BRIEFING NOTES
Planning Committee – 1 November 2023

ITEM 01 – The Hambrough Tavern, The Broadway, Southall

ITEM 02 – Sherwood Close (Former Dean Gardens Estate), West Ealing

ITEM 03 – 13-15 The Green, Southall

Amendment to Figure 47 (Basement Plan) of the Committee Report

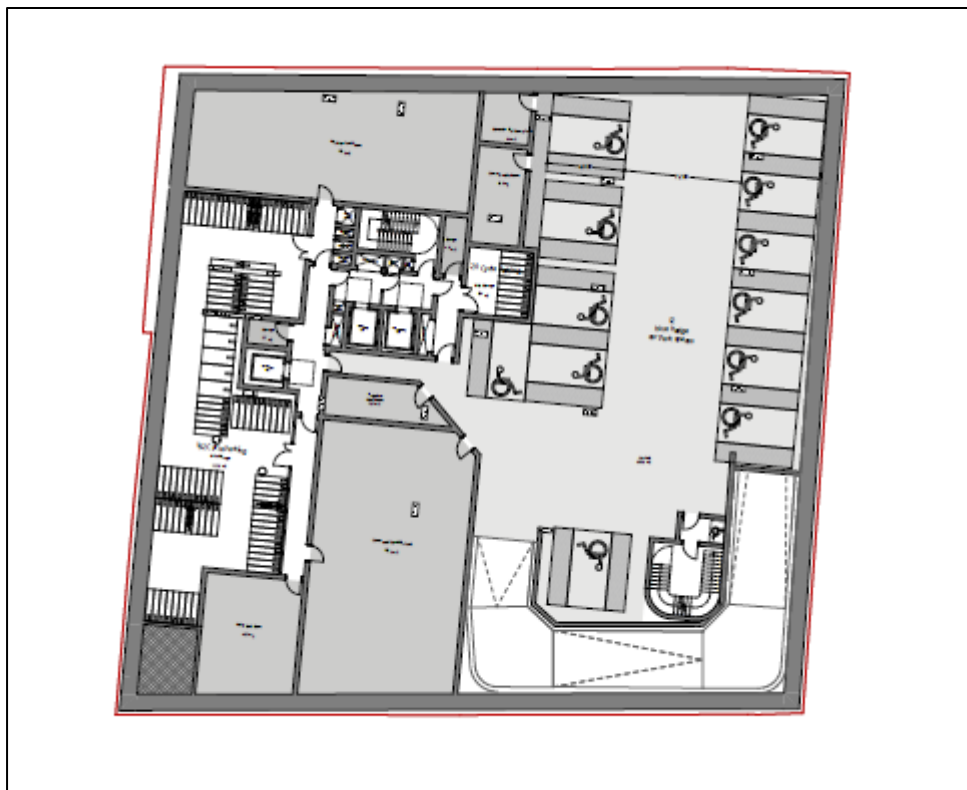
An incorrect version of the Basement Plan has been provided within the Committee Report. The image of the Basement Plan should be as follows:
